ADDENDUM NO. 1

**Water & Wastewater Improvements
Graham Cave State Park
Danville, Missouri
Project No. X2321-01**

Bidders are hereby informed that the construction Plans and/or Specifications are modified as follows:

E-102

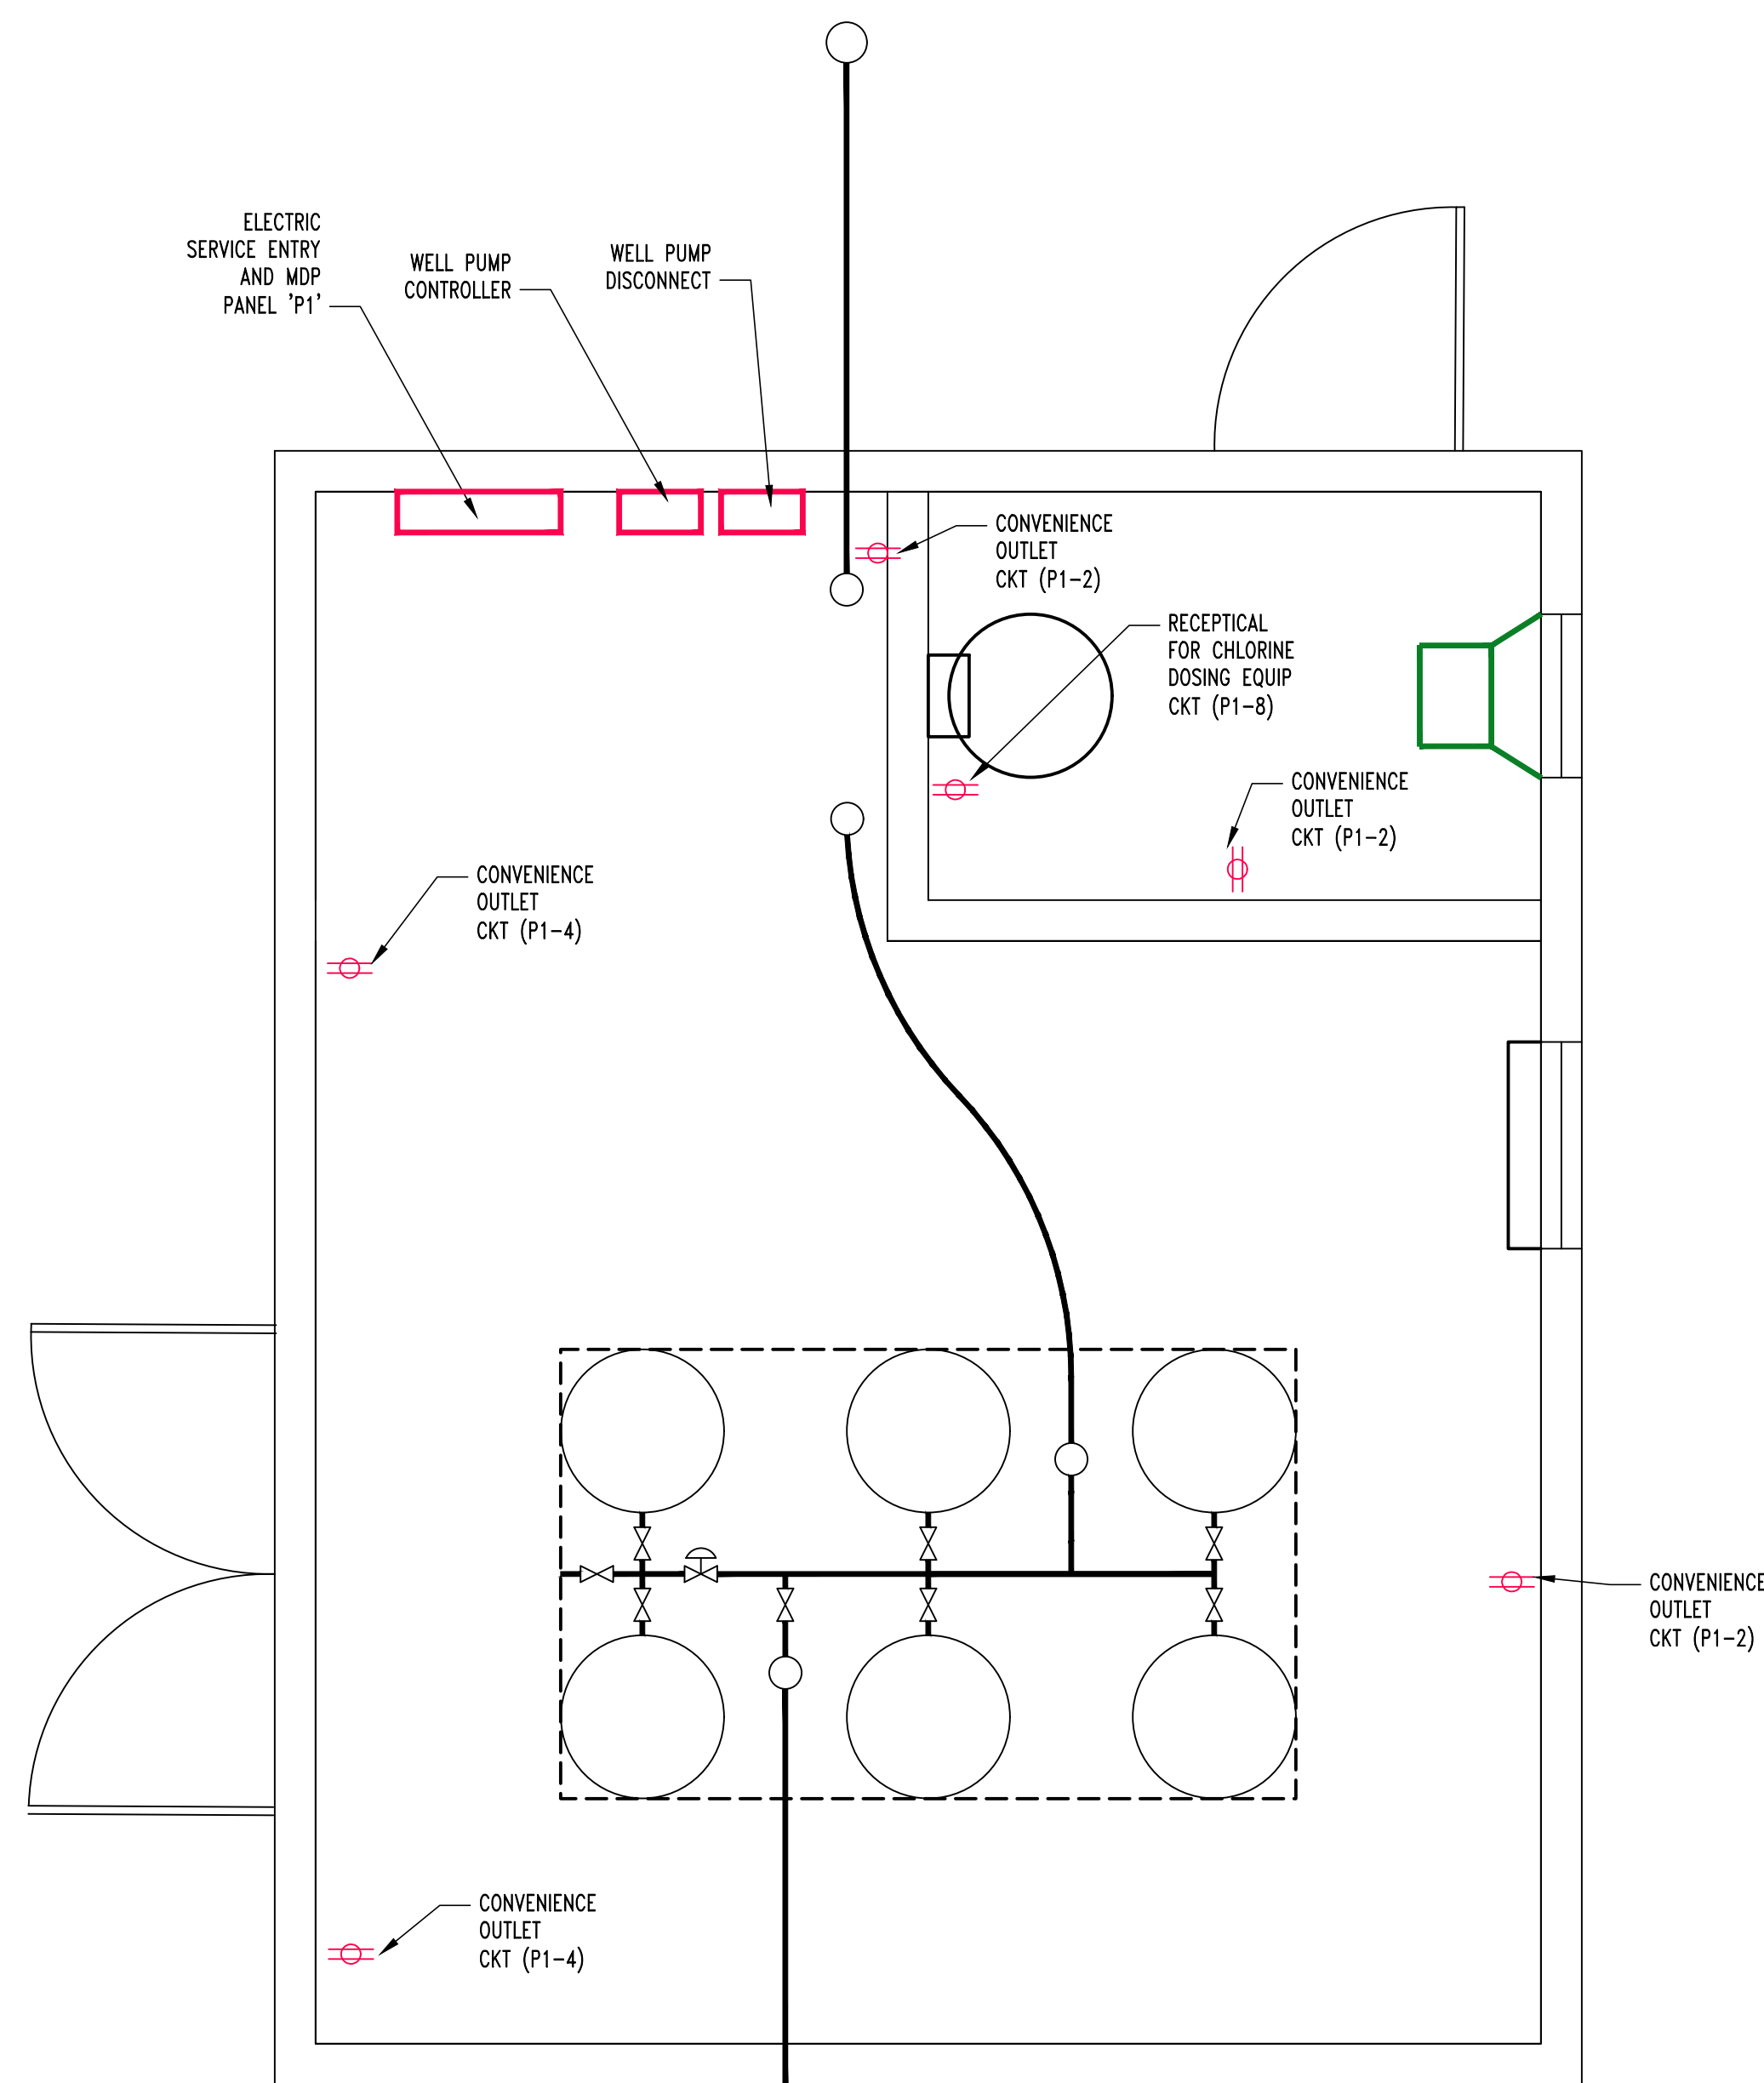
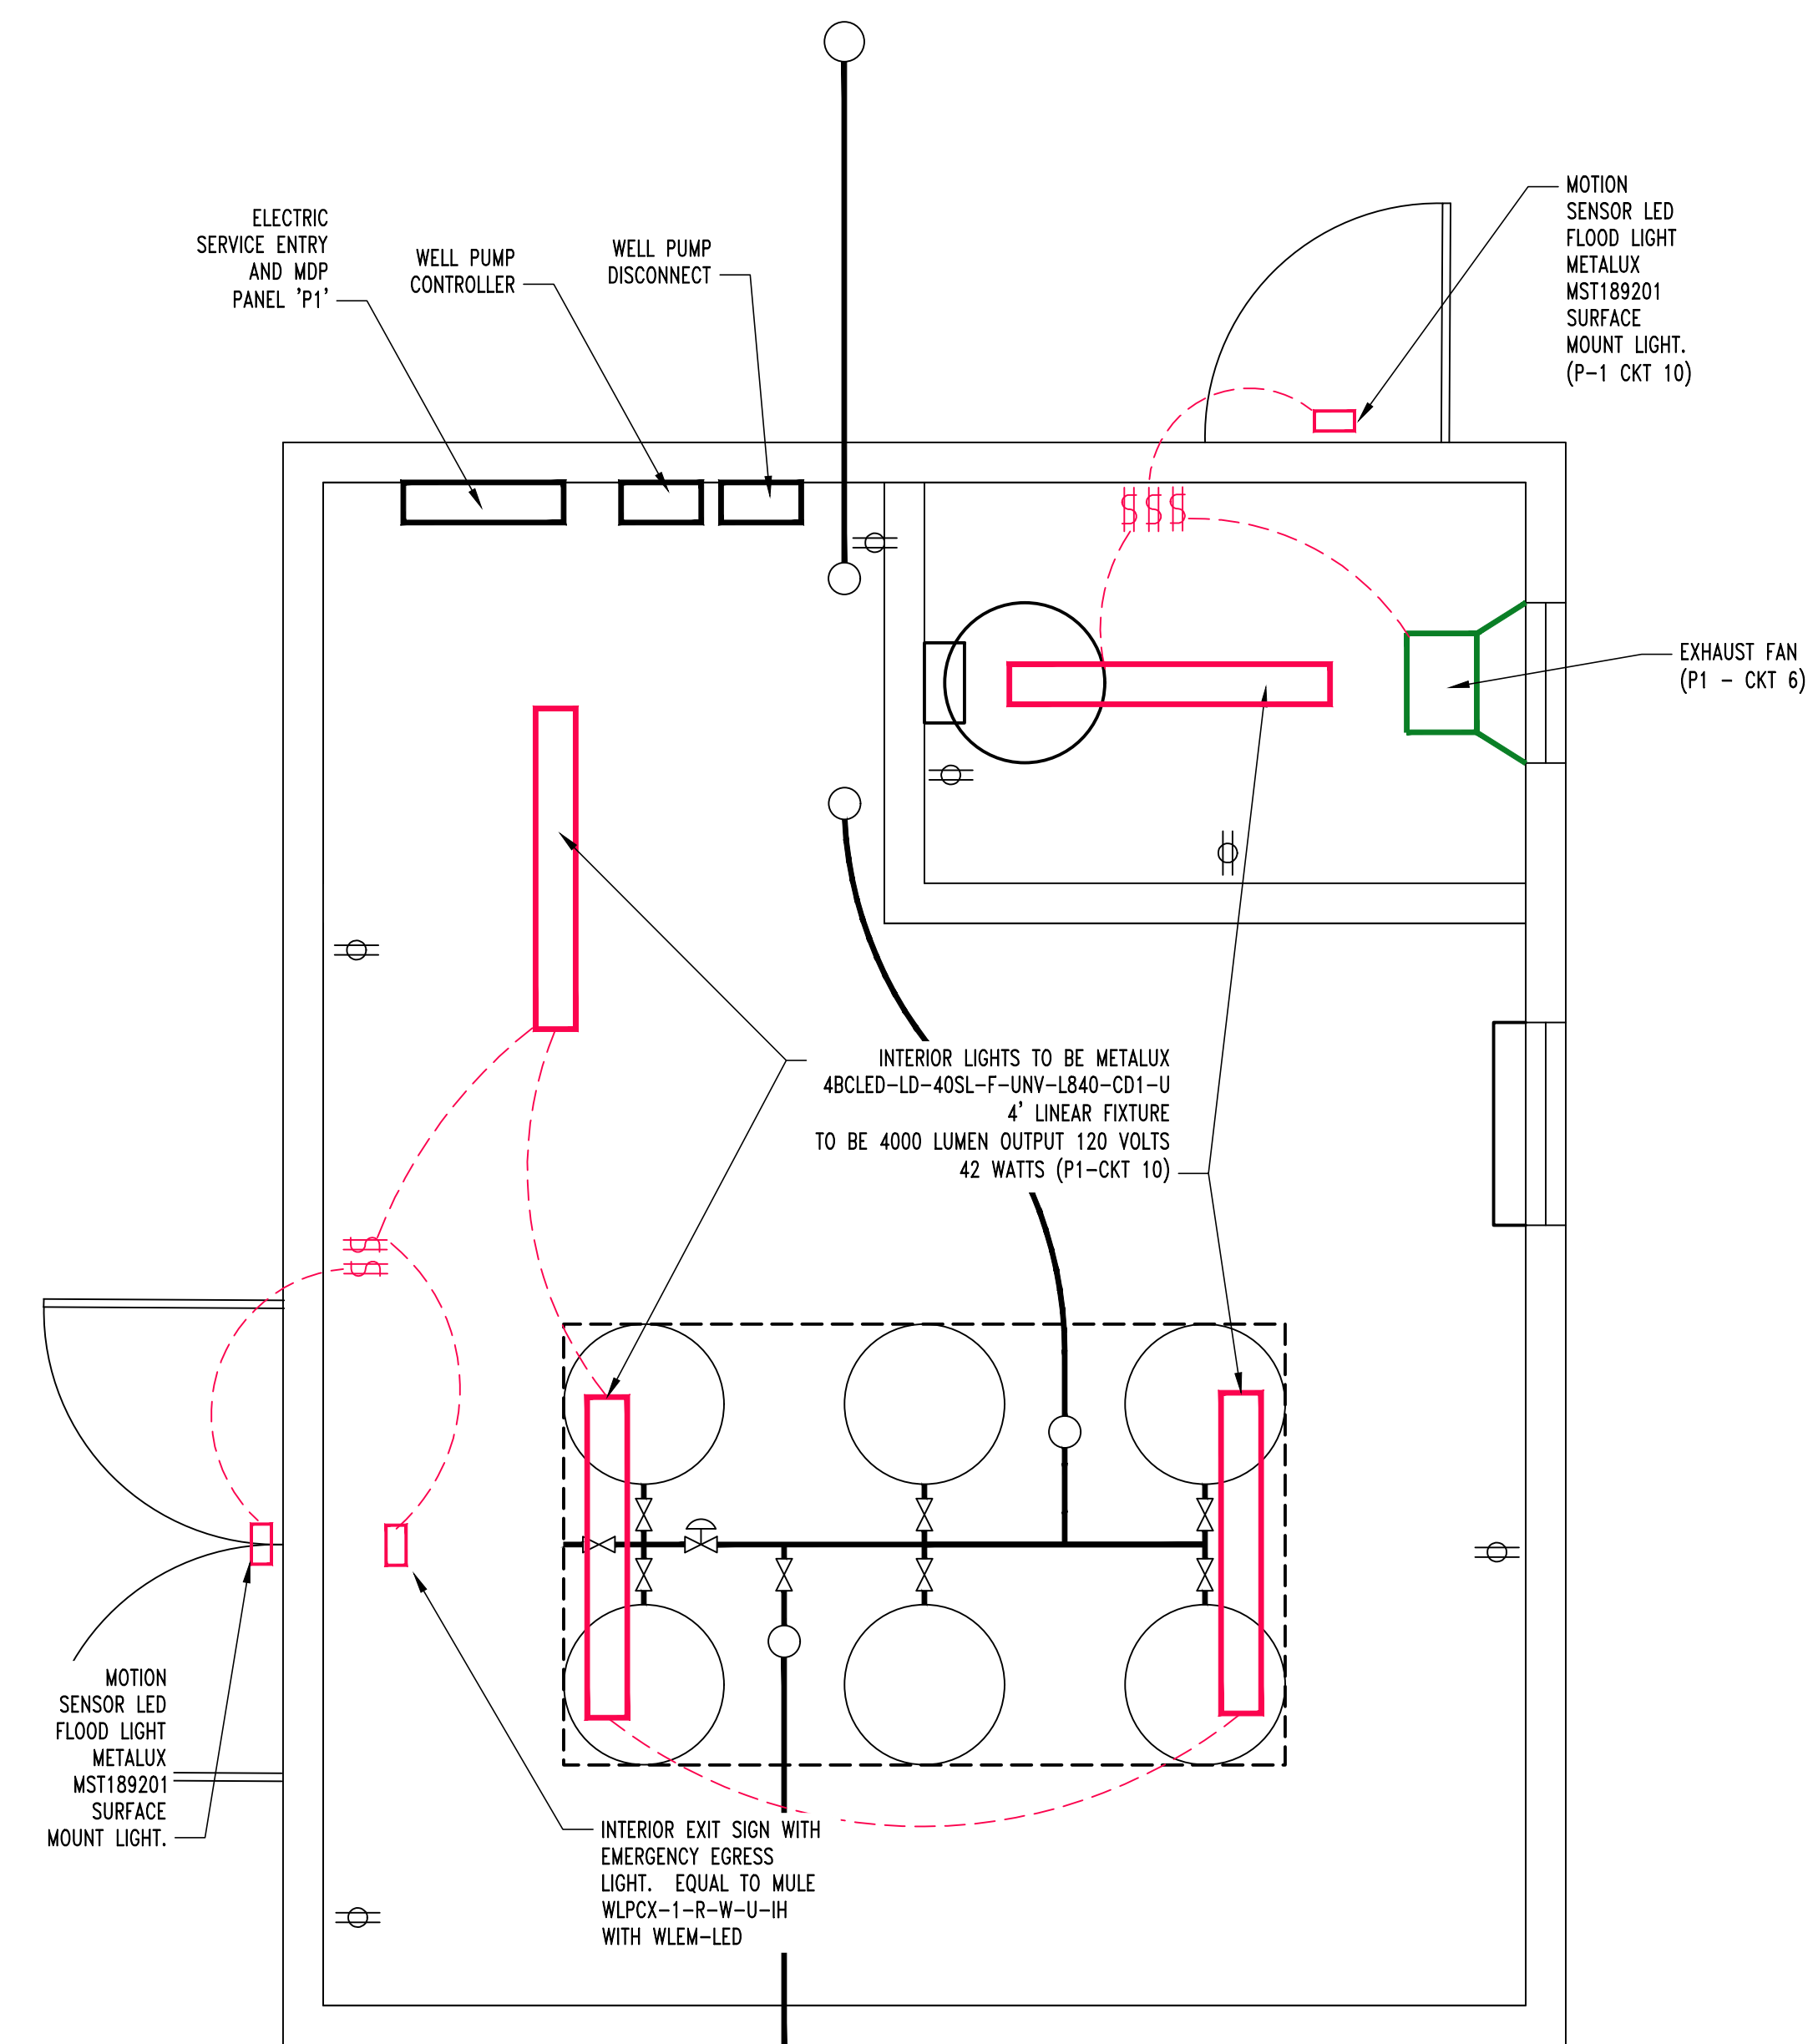
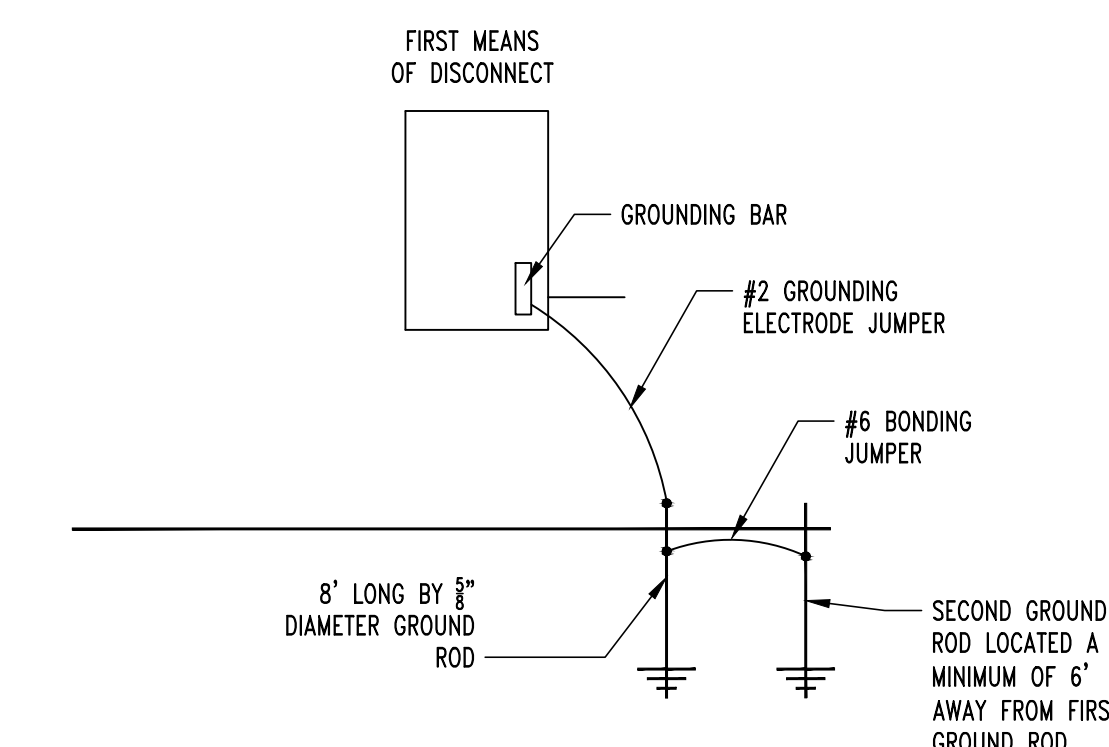
10. Sheet E-102
 - a. Circuit added for fuel pumps.
 - b. Riser diagram amended to show fuel pump circuit and conduit and wiring from panel to fuel tank.

- c. See attached revised drawing.
